1. HARDWARE COMPARAISON

BDDrive : ODrive v3.4 modified

2. MODIFICATIONS

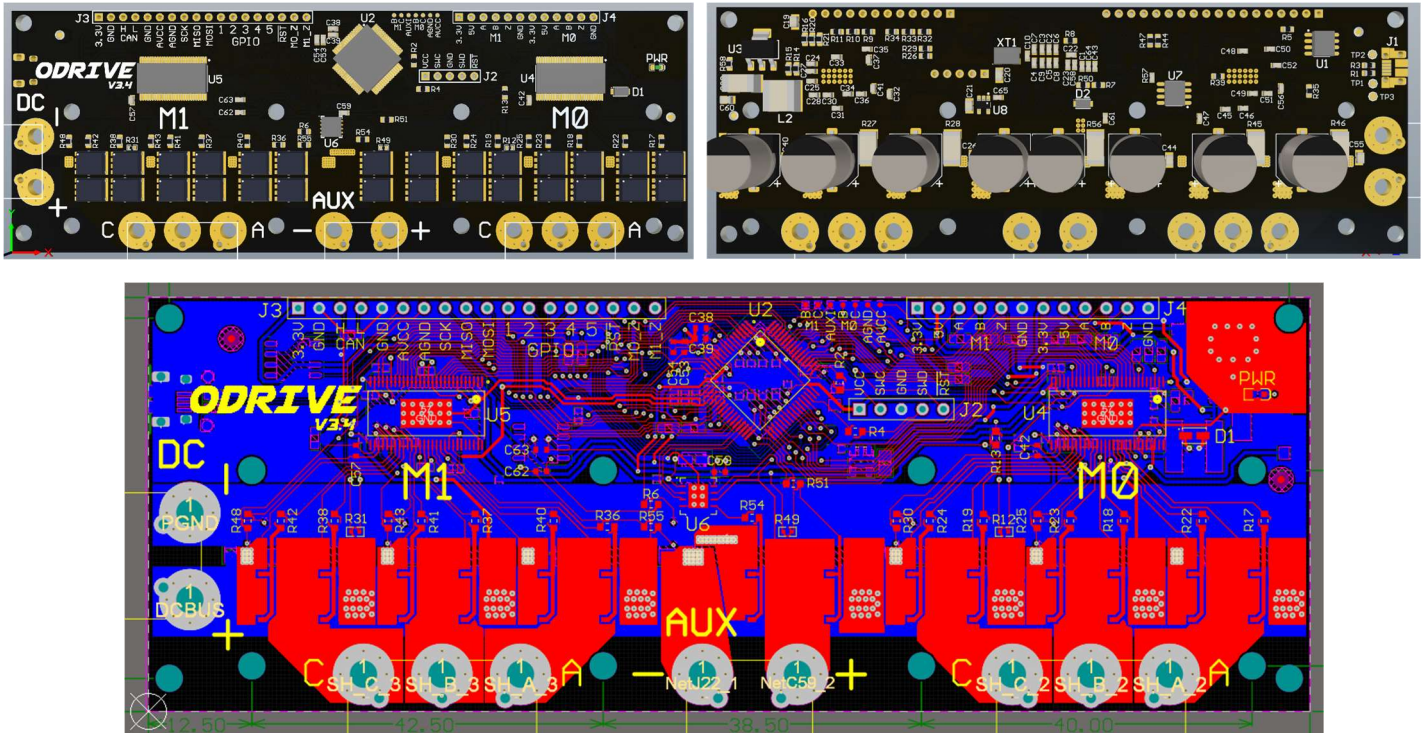
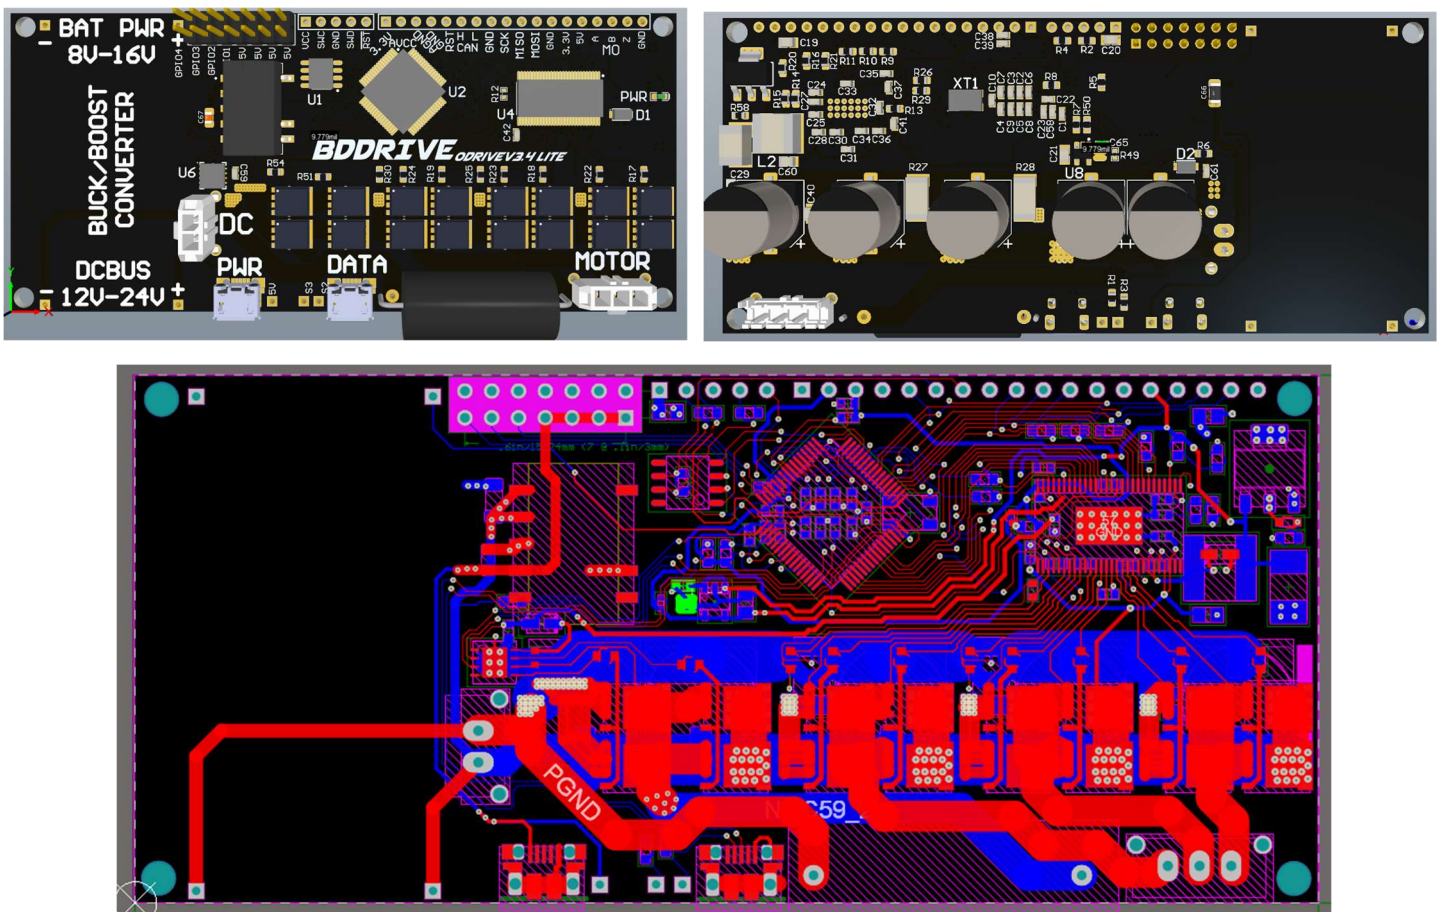
- Remove support for two motors (remove M1), so right now BDDrive can only control one brushless DC motor
- Use Molex connectors instead of screw in connectors to facilitate harness setup and the screw in connectors were proven as unreliable

- Add another 5V @ 1A power supply to supply a Raspberry Pi with the BDDrive (it was estimated that the consumption of a Raspberry Pi Zero would be under 200 mA)

- Add external header with 5V supply outputs (4 power pins and 4 GND pins) and access to GPIO ports (3 GPIO pins and 3 GND pins)
- Fix problems with the ODrive v3.4 which are documented here:

- https://discourse.odriverobotics.com/t/drv-fault-on-odrive-v3-4/558?u=madcowswe
  - Go from two layers to four layers to keep the GND uniformed
  - Fix routing problems

- Modify shunt resistors to be able to have a low power motor (below 5 Amps)
  - https://discourse.odriverobotics.com/t/current-sensing-resistor-for-low-current-motors/377/2
